# DEVELOPMENT FACILITATIVE TEAM (DFT)

**PR-2022-007999**

SI-2024-00582– EPC SITE PLAN SIGN-OFF  
SKETCH PLAT 12-2-22 (DRB)

**Project Name:** 336 Woodward

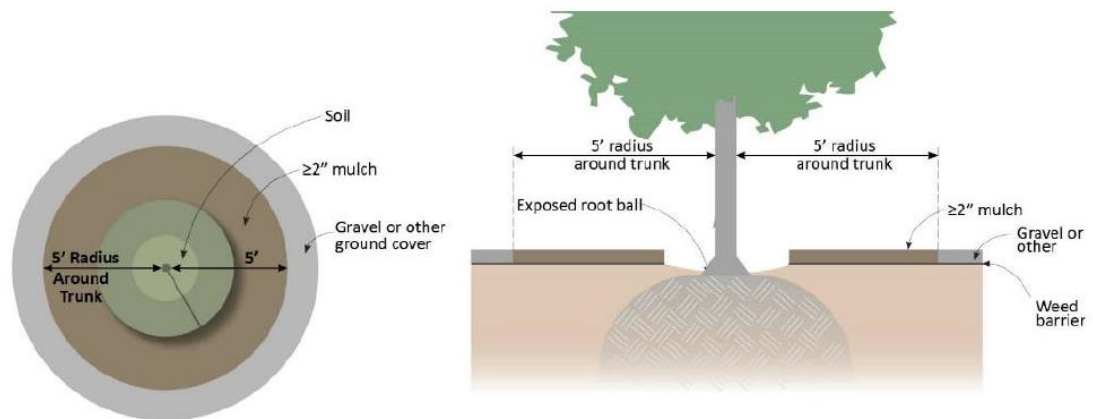
- All Site Plan sheets must be included in the site plan set for this submittal to the DFT including Architectural Plans, Elevations, and Landscape Plan.
- Site Plan sheet and all other sheets must be signed and sealed by a professional licensed in the state of New Mexico.
- “Site Plan Notes” have been added to the revised Site Plan. Most of these notes indicate compliance with the conditions stated in the 11/16/23 NOD. However, these notes currently include an error stating that the site’s zoning is CR-LM. This is incorrect. The site’s zoning is NR-LM, which is shown on the EPC approved Site Plan.
